: 10/712,611

: FASTENER ASSEMBLY

: JEFFREY ANDREW SHARP

PETITION TO THE DIRECTOR UNDER 37 C.F.R. § 1.181(a)(2)

FIG.30

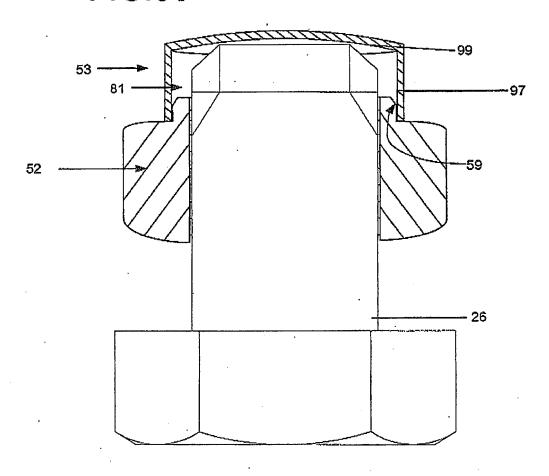
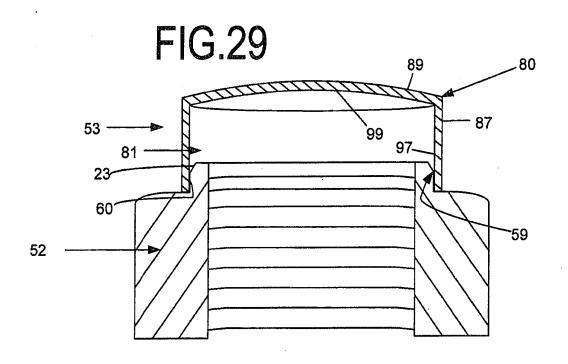
In the Office Action mailed on May 17, 2007, the Examiner objected to Figure 30 on grounds that the spherically shaped annular bearing surface located on the "lower side of the body" constituted new matter. See 05-17-2007 Office Action, Pg. 2, Il. 12-13. Specifically, the Examiner objected to amended Figure 30 under 35 U.S.C. § 132, stating "it [Fig. 30] introduced new matter into the disclosure." Id. The Examiner further stated:

The added material which is not supported by the original disclosure is as follows: the location of the spherical annular bearing surface on the body was not previously disclosed. Therefore, the new replacement sheet effectively introduces matter, which previously has not been disclosed by illustrated a particular location for the annular bearing surface having a spherically convex shape—said location being a lower side of the body. <u>See</u> 05-17-2007 Office Action, Pg. 2, Il. 14-19.

[3] The drawing(s) were previously objected for informalities. Applicant submitted a replacement sheet on 28 February 2007 to address claimed subject matter (spherically convex annular bearing surface) not shown.

The amendment filed 28 February 2007 is objected to under 35 U.S.C. 132(a) because it introduces new matter into the disclosure. 35 U.S.C. 132(a) states that no amendment shall introduce new matter into the disclosure of the invention. The added material which is not supported by the original disclosure is as follows: the <u>location</u> of the spherical annular bearing surface on the body was not previously disclosed. Therefore, the new replacement sheet effectively introduces matter, which previously has not been disclosed by illustrating a particular location for the annular bearing surface having a spherically convex shape -- said location being a lower side of the body.

Applicants submit a Replacement Sheet for the newly amended Figure 30. Per Examiner's suggestion, the amended Figure 30 now includes an annular bearing surface on the body that is spherically convex in shape. The amended Figure 30 is now consistent with the Specification. No new matter is introduced.

The drawing (i.e., Figure 30) was objected to under 37 C.F.R. § 1.83(a). The Examiner pointed out, while admitting the feature is fully disclosed in the specification, that Figure 30 does not include an annular bearing surface on the body that is spherically convex in shape.

Applicant is required to cancel the new matter in the reply to this Office Action.

Applicants respectfully submit a Replacement Sheet for Figure 30 showing an annular bearing surface on the body that is spherically convex in shape. No new matter is introduced.
